# Dongara Titanium Minerals Project

Response to submissions

November 2012

Figure 6: Predicted groundwater drawdown in the Superficial Aquifer with hydraulic conductivity multiplier 0.5 to base case

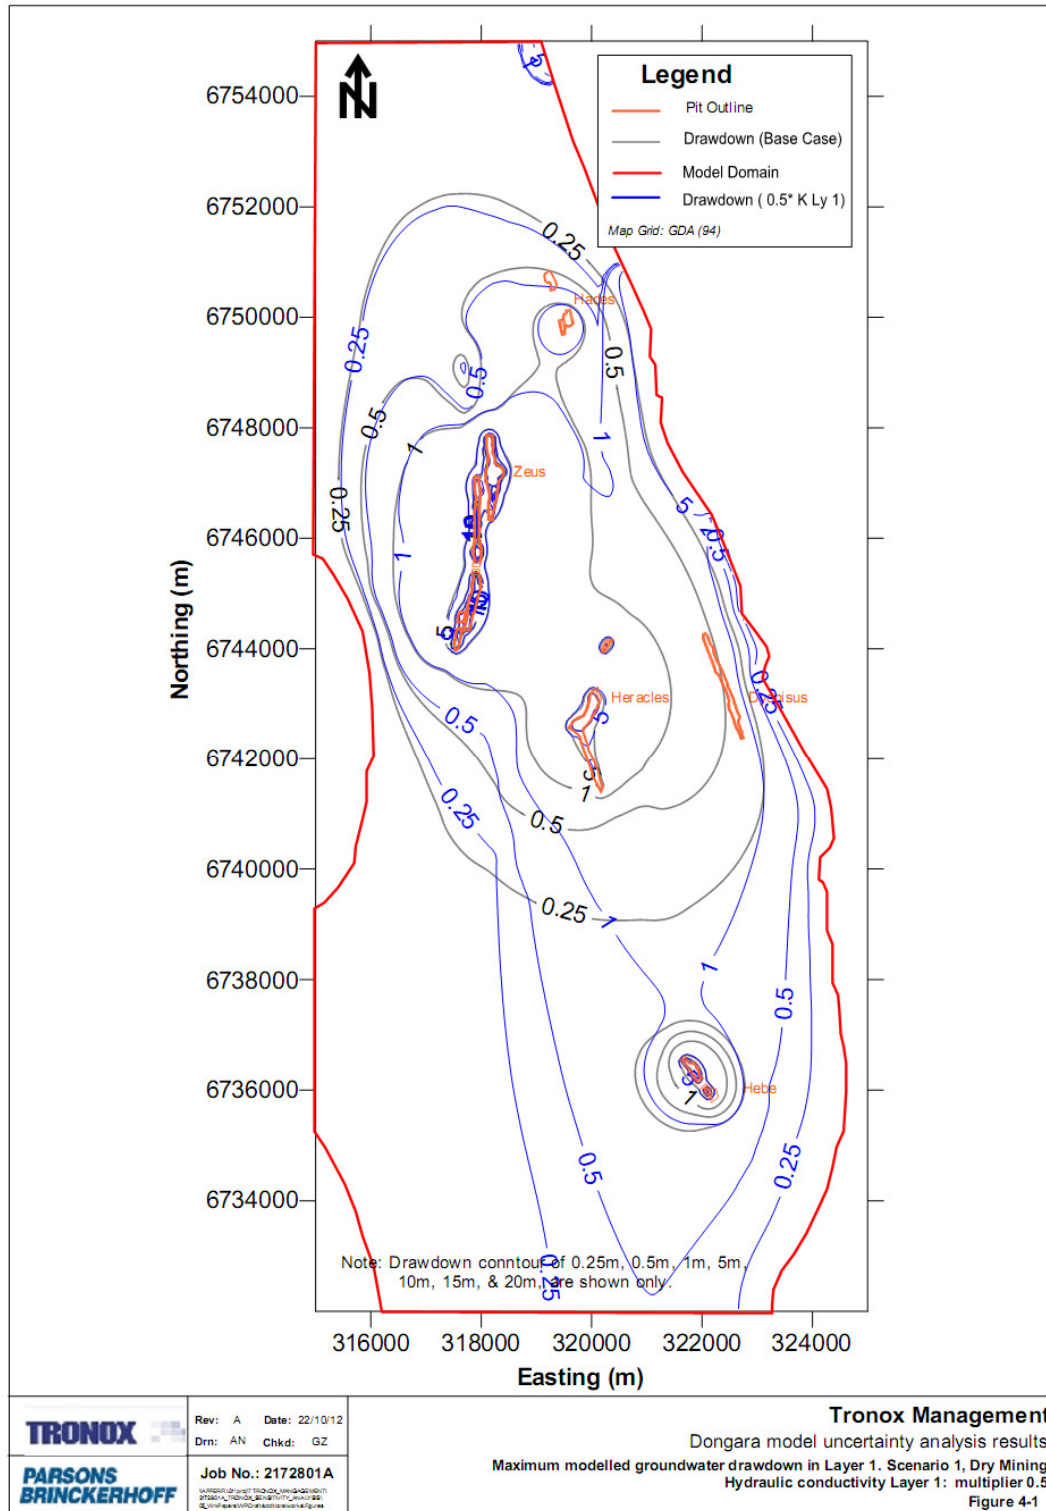
7.		DoW considers the pump testing (Parsons Brinckerhoff, October 2011) was not of a sufficient time to measure groundwater variations in the shallow semi connected aquifer system and did not include shallow observation bores to evaluate system connectivity. This has resulted in the inability to test or verify the connectivity of the Superficial aquifer with the underlying Yarragadee aquifer. If the proposal is approved, DoW will require a model revision be undertaken prior to the granting of a Section 5C groundwater licence. Further technical advice can be found in Appendix A.	Noted. Tronox have provided a detailed response to specific comments from DoW in Section 2.

1. A decrease in the hydraulic conductivity (0.5 multiplier) in the Superficial Aquifer (Layer 1) increased the severity of drawdown by extending the 2 m contour to include Heracles, the 1 m to include Hebe and the 0.5 m approximately 3 km south of Hebe (see Figure 6).
2. An increase in the hydraulic conductivity (2 multiplier) in the Superficial Aquifer (Layer 1) resulted in a reduction of the area impacted by drawdown with the 0.25 m contour remaining within 2 km of Zeus and Heracles compared to the base case where the 0.25 m contour extends up to 4 km from Zeus (Figure 7).

Figure 10: Proposed layout of reinjection system and maximum drawdown with artificial recharge

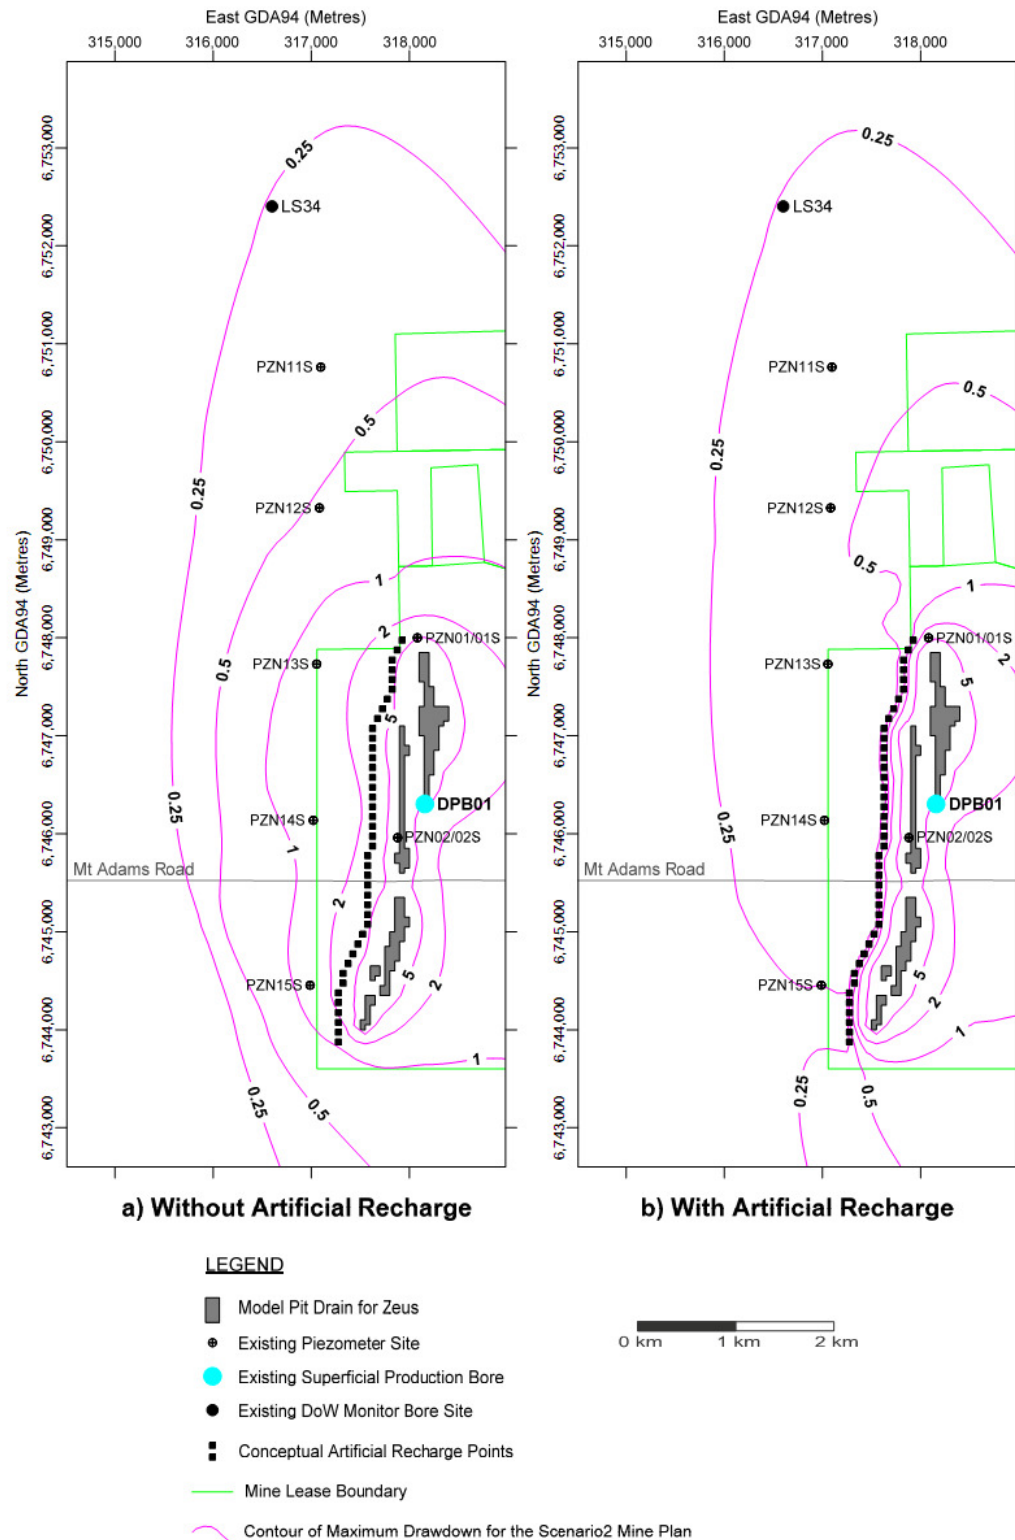
8.		The current modelled groundwater drawdown predicts an impact on groundwater levels in the Superficial aquifer that would affect up to 373 ha of pristine-excellent condition vegetation and Conservation Category wetlands (Woodman 2009 and Endemic 2012). The PER interprets these impacts as not significant (Executive Summary pg vi & vii). The DoW considers these impacts to be significant and recommends the OEPA acknowledges possible loss of ecological value as a consequence of the mining activity. For further technical advice please refer to Appendix B.	<p>Tronox considers that this comment misrepresents the findings of the impact assessment. The impacts associated with mine dewatering are presented in terms of the potential change in the extent of:</p> <ul style="list-style-type: none"> <li>• groundwater dependent ecosystems (GDEs)</li> <li>• wetlands</li> <li>• vegetation units (communities and associations).</li> </ul> <p>• Section 7.5.1 of the PER, states that the total area of GDEs predicted to be impacted (i.e. experience a measureable change) is 8.5% of the total local extent of GDEs, with the extent of large change (severe impact) limited to 4.6%. In other words, 3500 ha of the 4369 ha of GDEs mapped within the project area will not be impacted to any measureable extent.</p> <p>• Drawdown is not expected to impact the Heracles or Hebe wetlands and will impact 24% of the extent of the Zeus wetland. This equates to 16% of the total areas of wetlands mapped within the Project area.</p> <p>• At a vegetation community level, Table 34 of the PER shows that less than 10% of any vegetation unit will be impacted with the exception of FCT 10a of which approximately 41.4% will be impacted (by drawdown and clearing).</p> <p>• Based on these findings the impact assessment considered the Proposal will not significantly reduce the distribution of vegetation types or wetland communities.</p> <p>• Tronox have considered additional mitigation options for reducing impacts to GDEs in response to DoW and OEPA's comments on the area predicted to be</p>

The recommended conceptual design of the reinjection system includes a ~4.2 km long transect of 42 small infiltration trenches orientated north-south approximately 250 to 300 m west of the Zeus Pit (as shown in Figure 10). The trenches will be approximately 0.5 m deep, 1 m wide and 3 m long.

The reinjection system is predicted to maintain groundwater drawdown to less than 0.5 m west of the line of recharge as shown in Figure 10. Based on the reduction in groundwater drawdown from the operation of the reinjection system, the GDE risk areas have been recalculated and are presented in Section 2.3.

#	PER Section.	Reviewer comment/recommendation	Proponent response
			impacted by groundwater drawdown. The preferred mitigation option, detailed in Section 2.2.2, consists of 42 infiltration points through which water is reinjected along a north south line approximately 250 – 300 m from the western edge of Zeus. Revised modelling including the reinjection predicts drawdown of no more than 0.5 m west of the infiltration points. Consequently the total area of GDEs predicted to be impacted with the reinjection system (i.e. experience a measureable change) is 2.4% of the total local extent of GDEs, reduced from 8.5% without the reinjection system. The extent of large change (severe impact) is predicted to be limited to 1.1%, a reduction of 3.3% from predicted impacts with no recharge. In other words, 4301 ha of the 4407 ha of GDEs mapped within the project area will not be impacted to any measureable extent.

Figure 15: Revised impact on conservation significant flora - dewatering (Revised PER Figure 32)

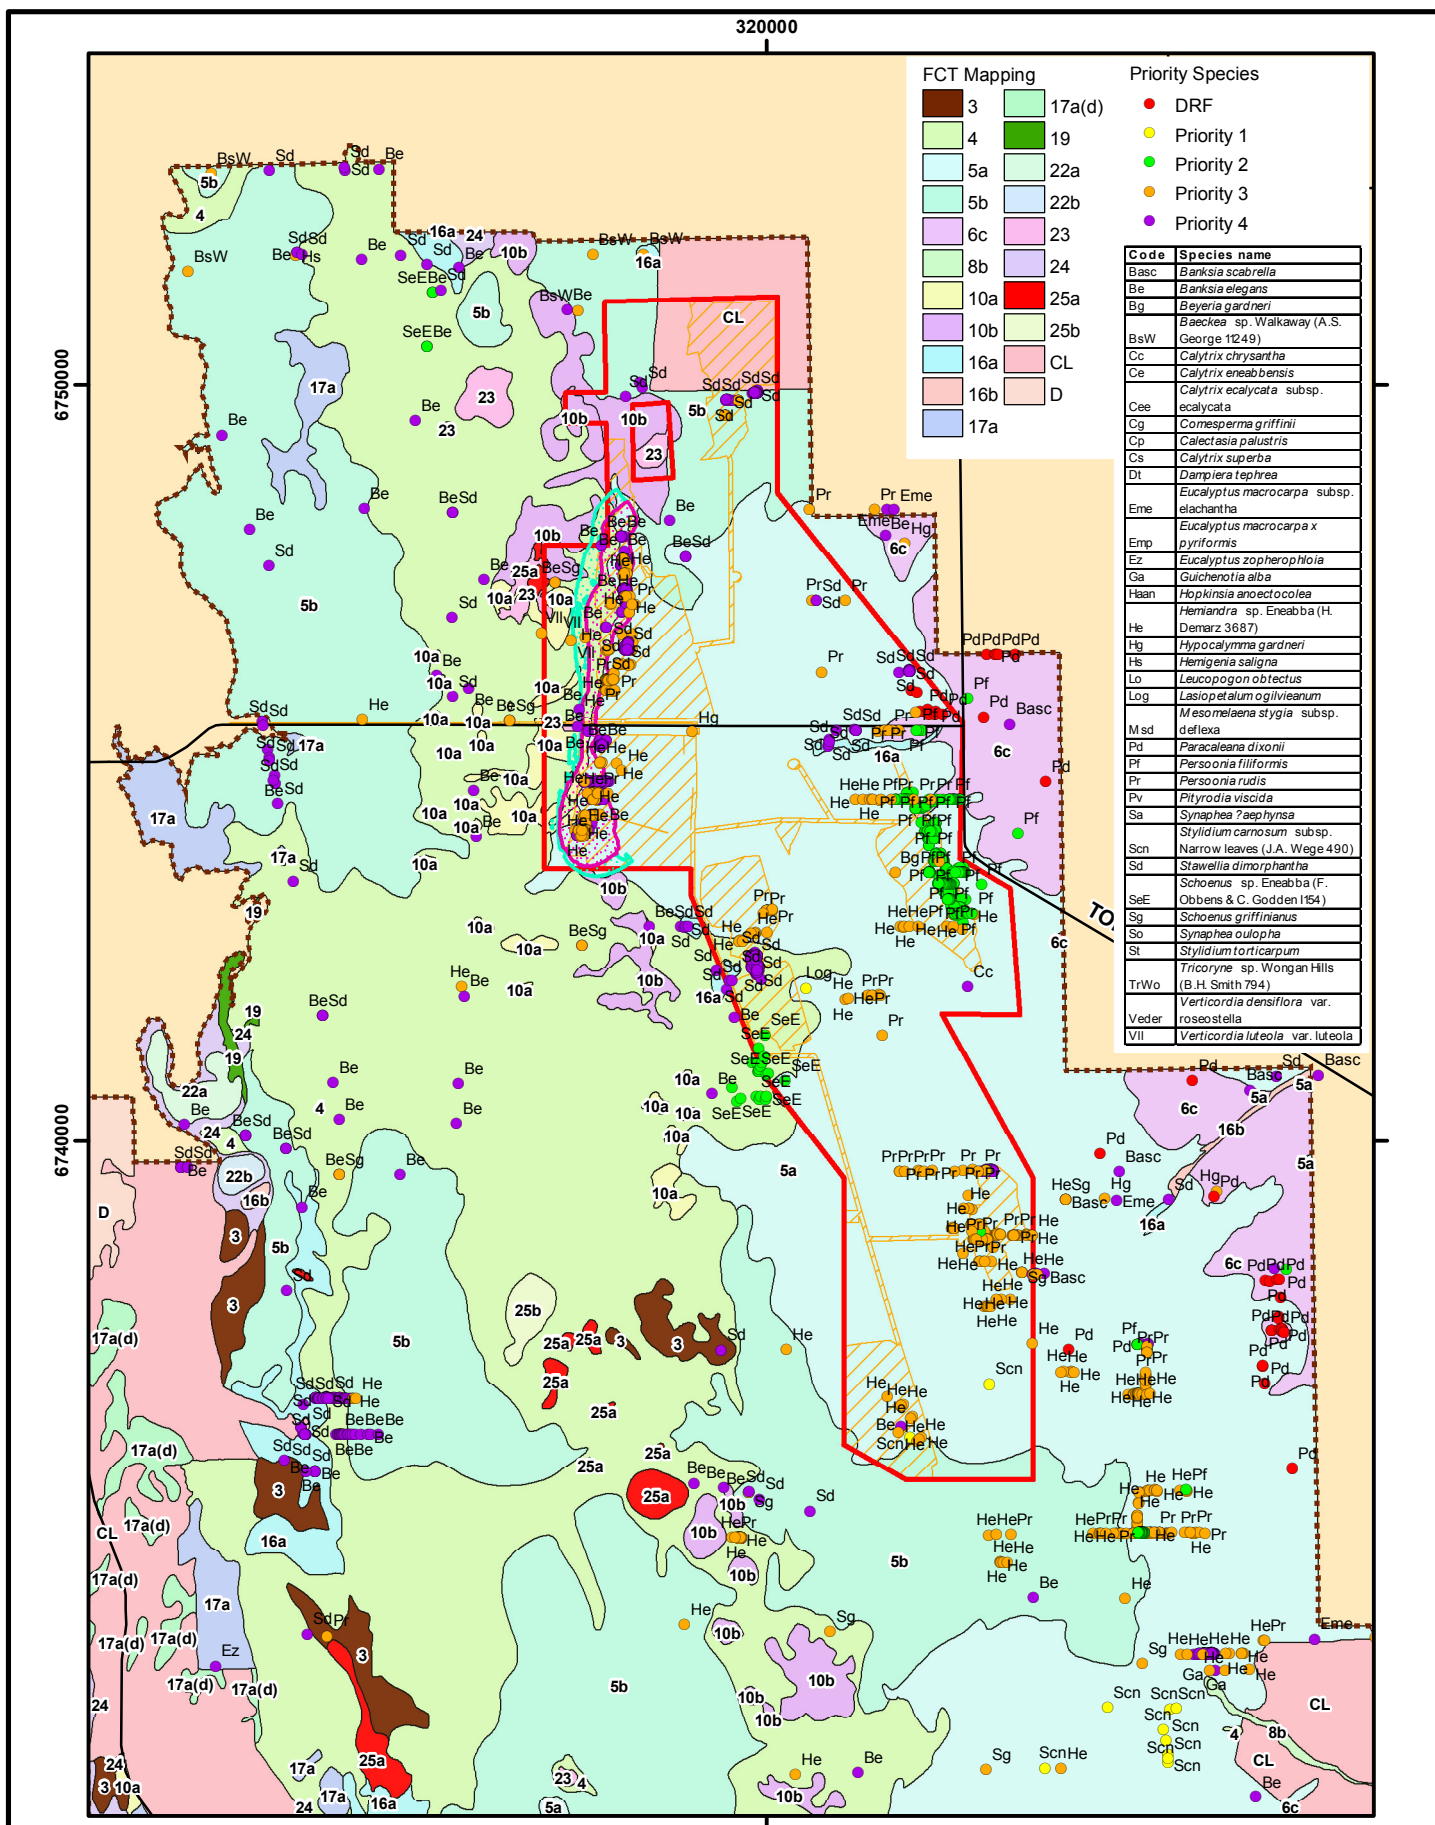
2.	PER 14.4.1	<p>Paracaleana dixonii</p> <p>What is the minimum buffer distance between the individuals which will be avoided and the clearing footprint?</p>	The proximity of the clearing footprint to the closest known Paracaleana dixonii individuals is approximately 600m refer to Figure 32 of the PER.

The recharge scheme reduces groundwater drawdown related impacts on the number of known locations of the conservation significant species, *Banksia elegans* and *Verticordia luteola* var. *luteola* to one (Table 5 and revised Figure 32 from the PER). No known locations of *Schoenus griffinianus* will be affected by drawdown.
